California Ridge Wind Farm Champaign County, IL

Natural Resource Report

October 6, 2011

California Ridge Wind Farm Natural Resource Report Summary

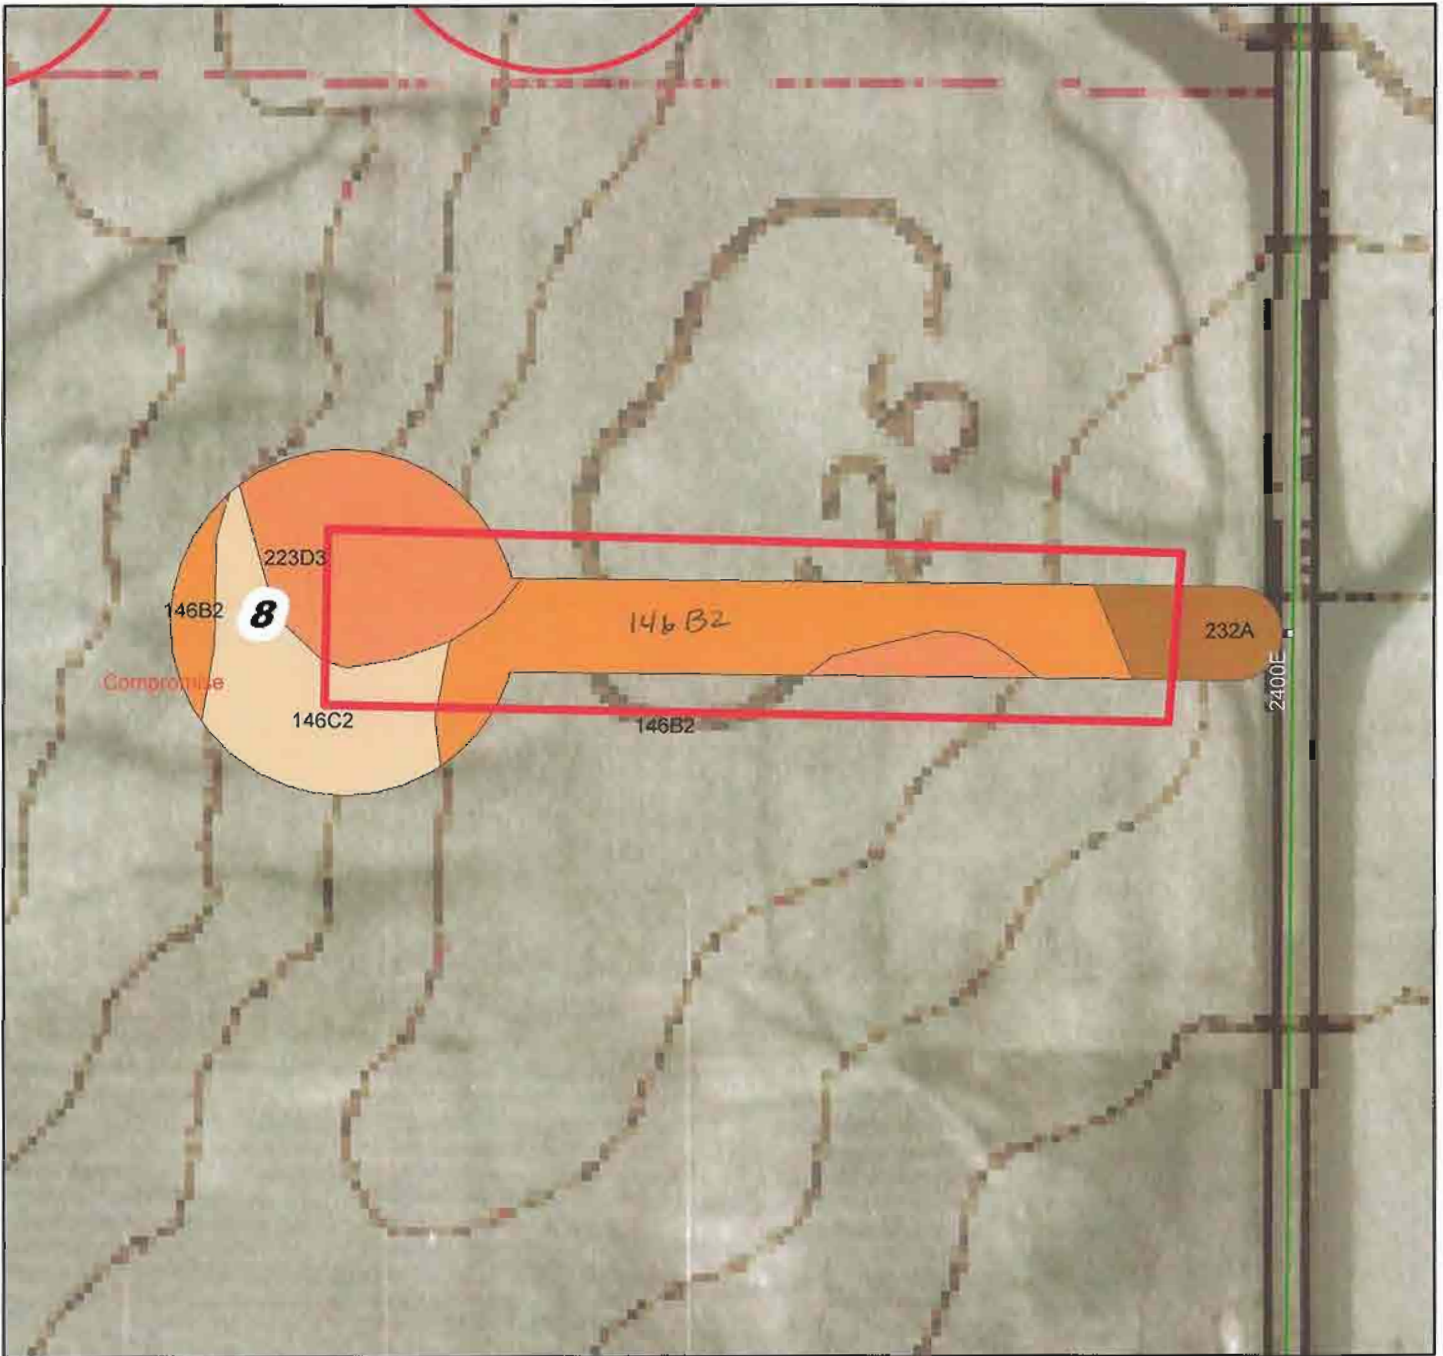
The 146B2 (Elliott Silty Clay Loam) soil has a 2-4% slope and 146C2 has a 4-6% slope that could cause erosion of the road surface or depositing silt on the access road and parking area. This site could also have erosion issues along the edge of the access road with gully erosion due to the orientation of the slope in relation to the road. The area most susceptible is outlined in a red rectangle.

The 223D3 (Varna Silt Loam) soil has significant slopes to them that could be an issue with water flowing over the access road possibly causing erosion of the road surface or depositing silt on the access road and turbine parking area. This site could also have erosion issues along the edge of the access road with gully erosion due to the orientation of the slope in relation to the road.

The area most susceptible is outlined in a red rectangle.

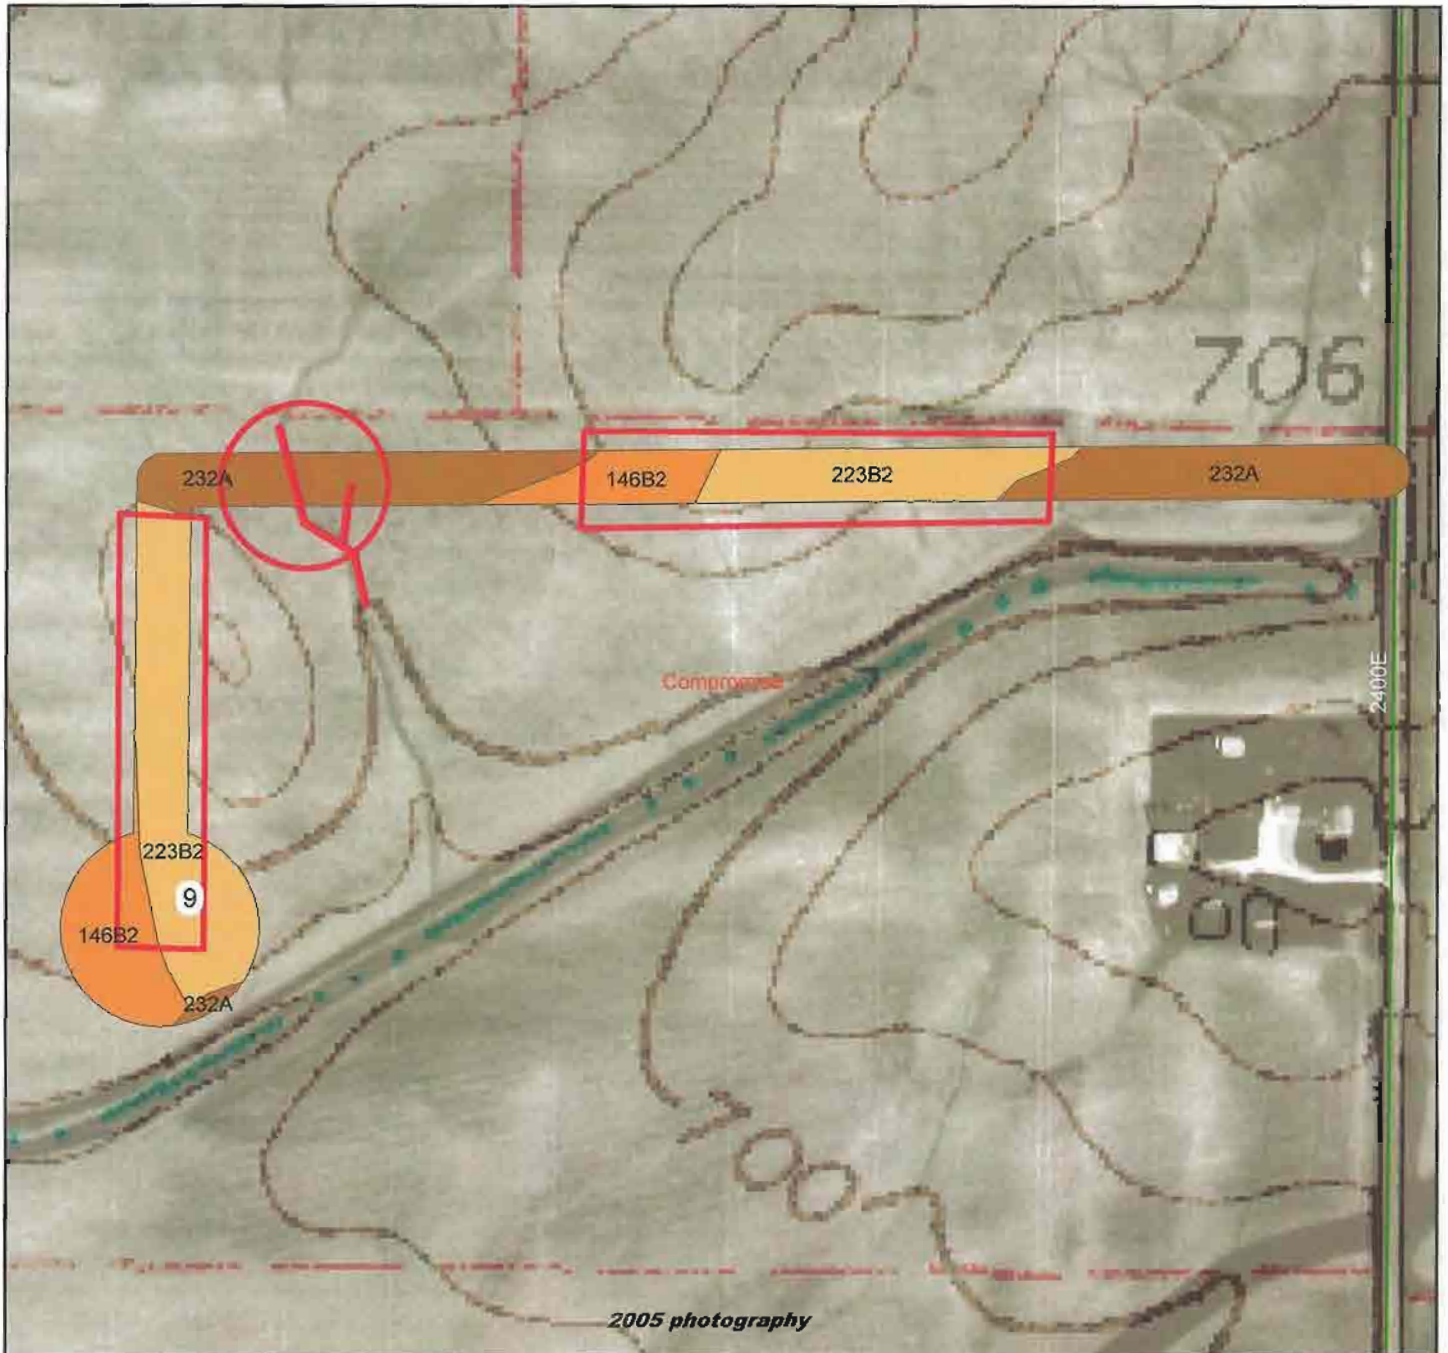
The 146B2 (Elliott Silty Clay Loam) soil has a 2-4% slope that could be an issue with water flowing over the access road possibly causing erosion of the road surface or depositing silt on the access road.

The 223B2 (Varna Silt Loam) soil has 2-4% slopes that could be an issue with water flowing over the access road possibly causing erosion of the road surface or depositing silt on the access road and turbine parking area.

The area most susceptible is outlined in a red rectangle.

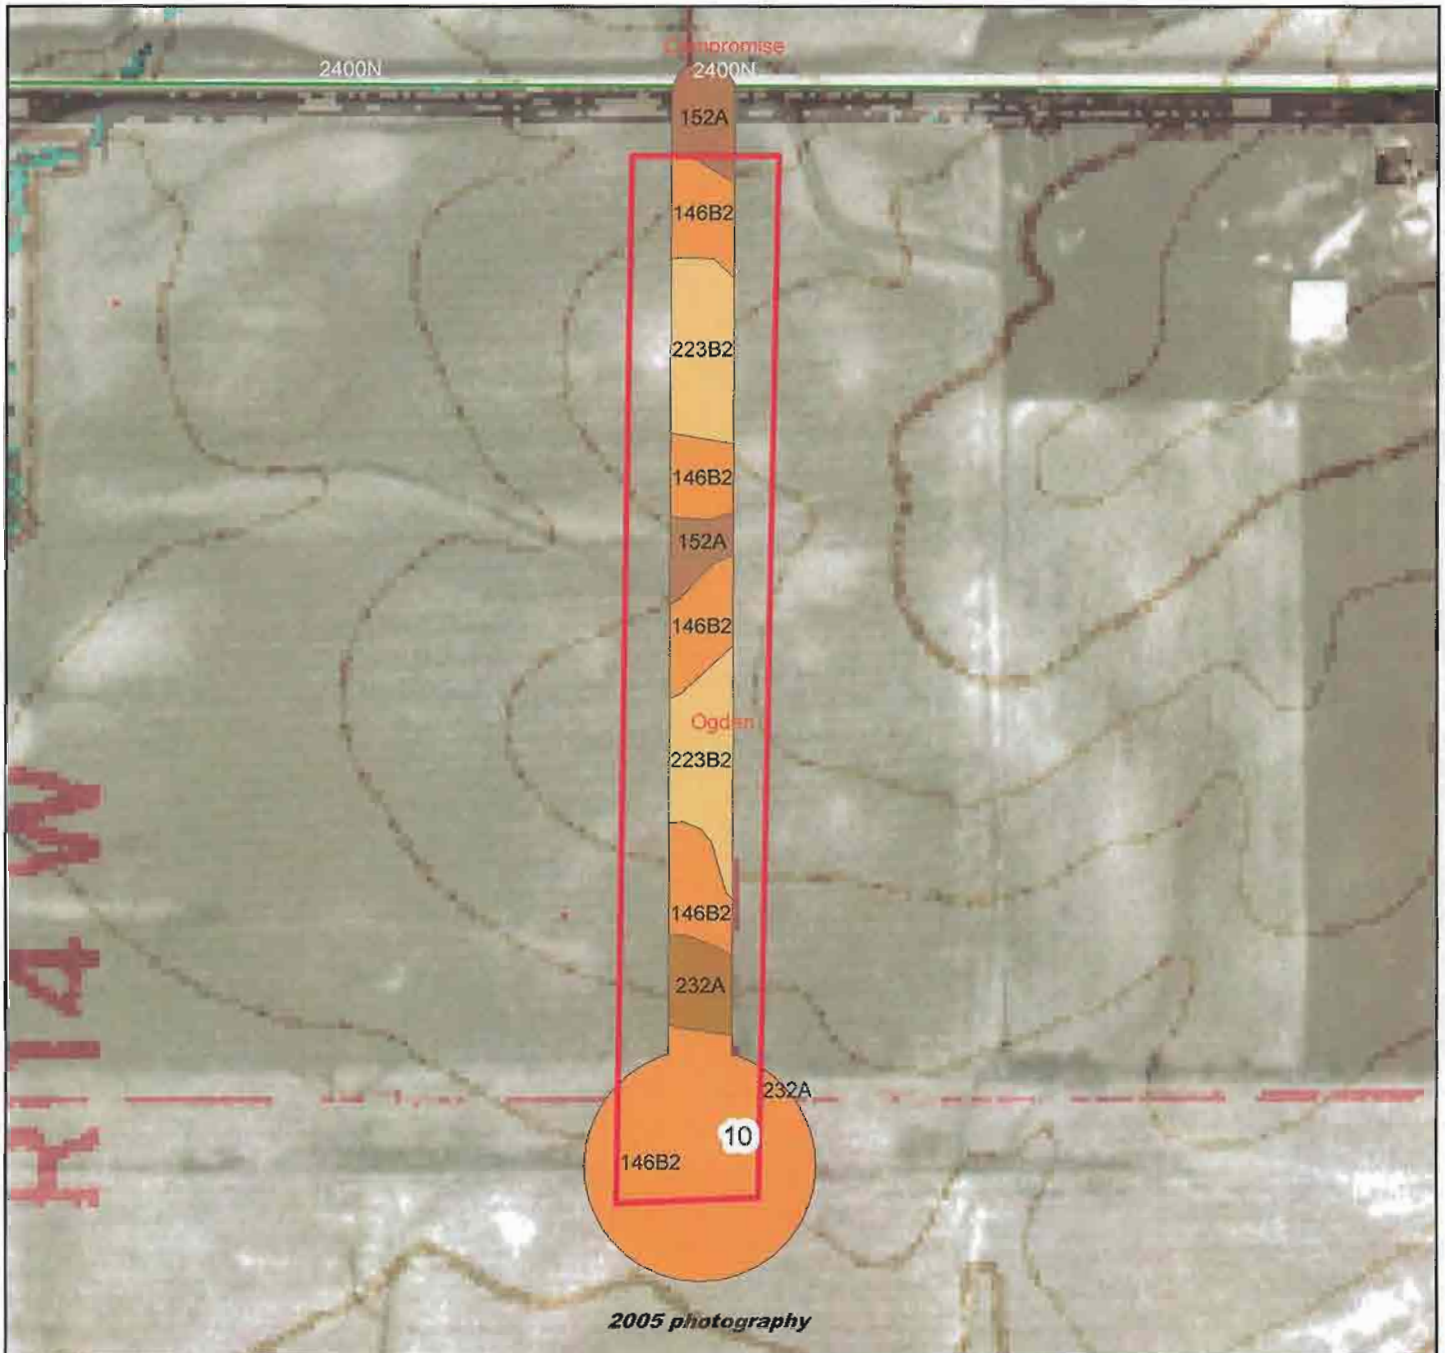
The 146B2 (Elliott Silty Clay Loam) soil has a 2-4% slope that could be an issue with water flowing over the access road possibly causing erosion of the road surface or depositing silt on the access road and turbine parking area.

The 223B2 (Varna Silt Loam) soil has 2-4% slopes that could be an issue with water flowing over the access road possibly causing erosion of the road surface or depositing silt on the access road.

The area most susceptible is outlined in a red rectangle.

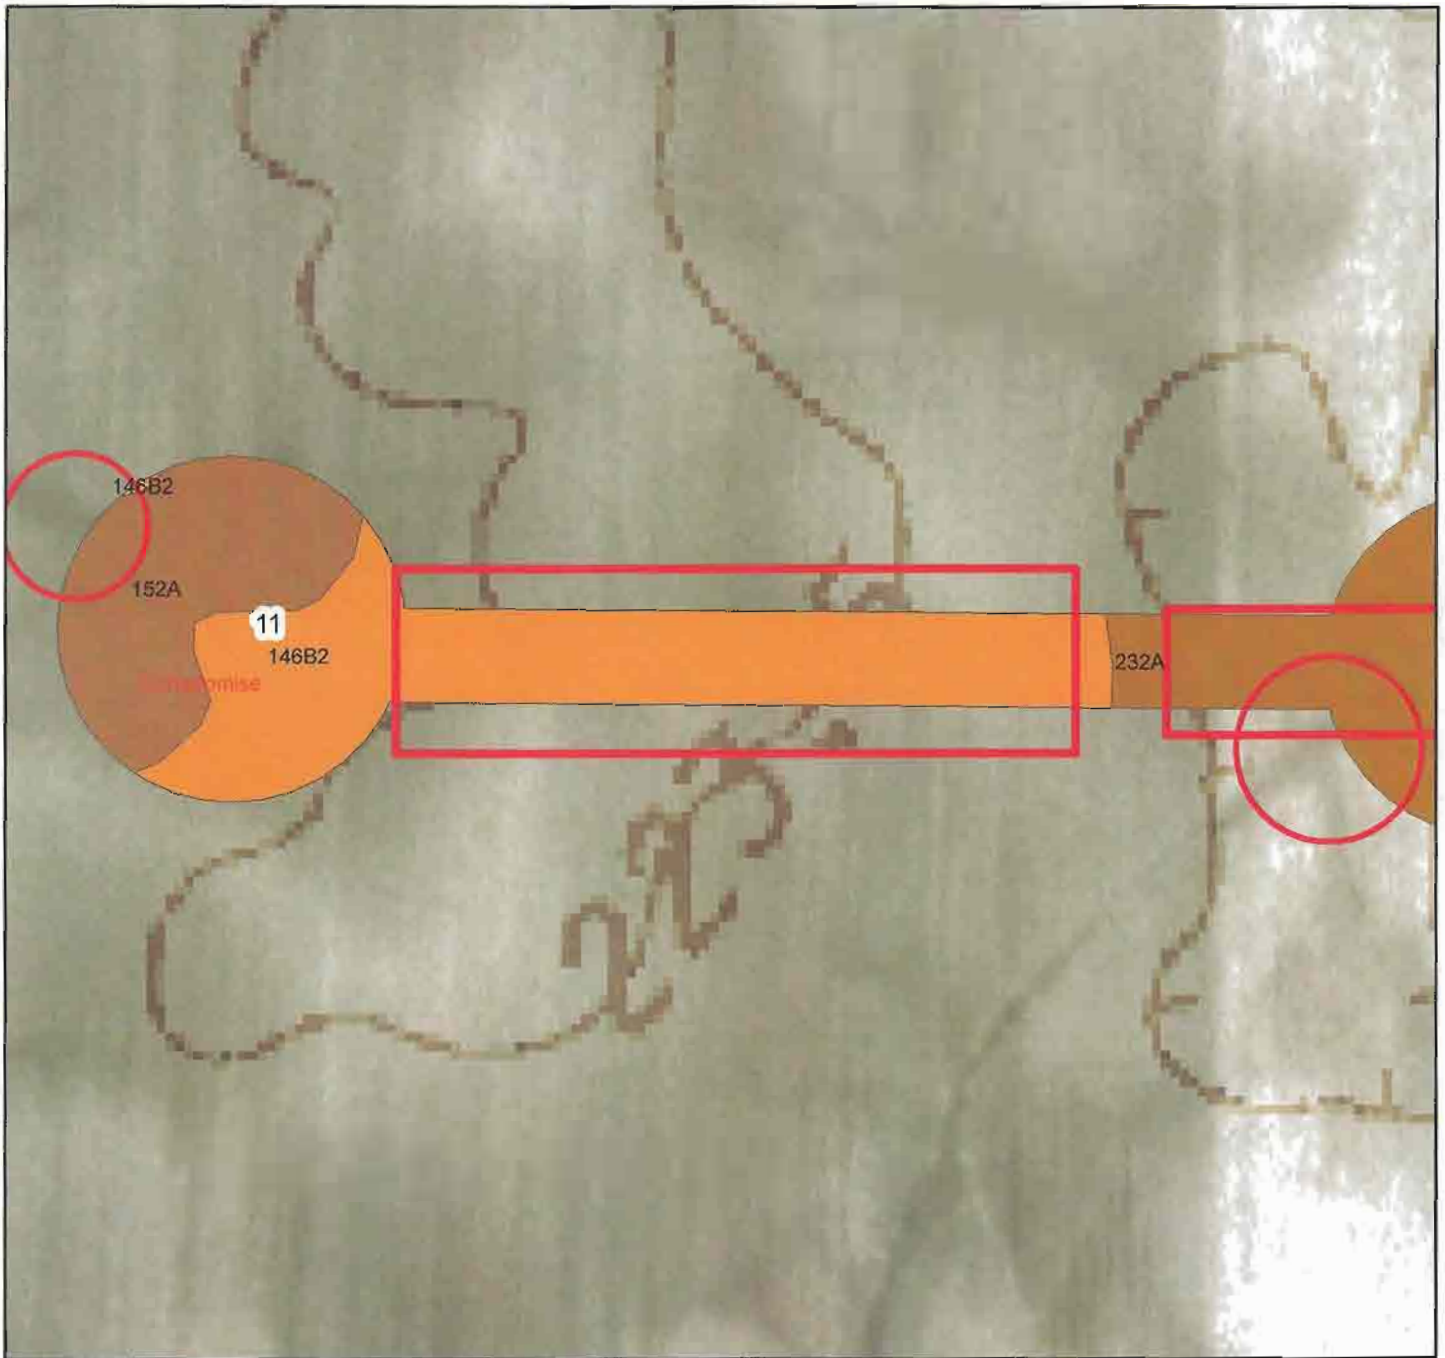
The 146B2 (Elliott Silty Clay Loam) soil has a 2-4% slope that could be an issue with water flowing over the access road and turbine parking area possibly causing erosion of the road surface or depositing silt on them. The area most susceptible is outlined in a red rectangle.

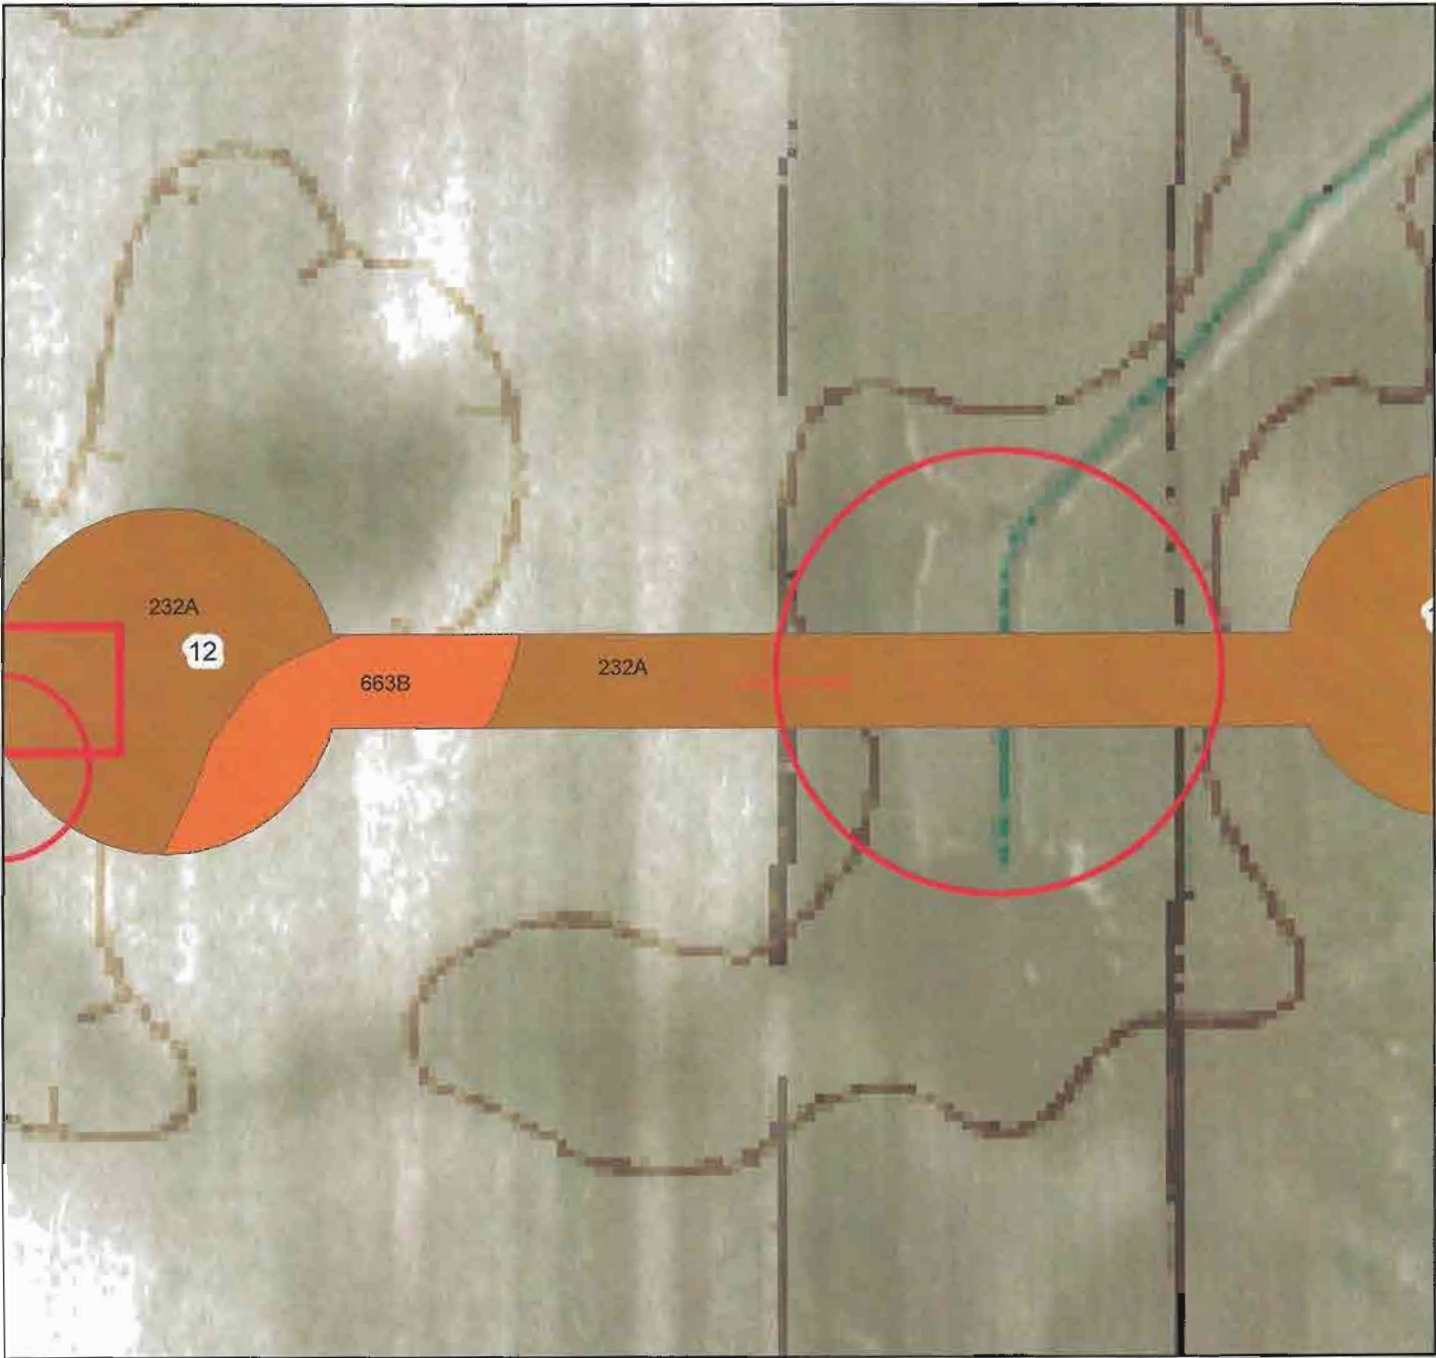
The site has some 663B (Clair) that has a 2-5% slope characteristic that could have an erosion issue, but the short length of the slope should minimize any issues.
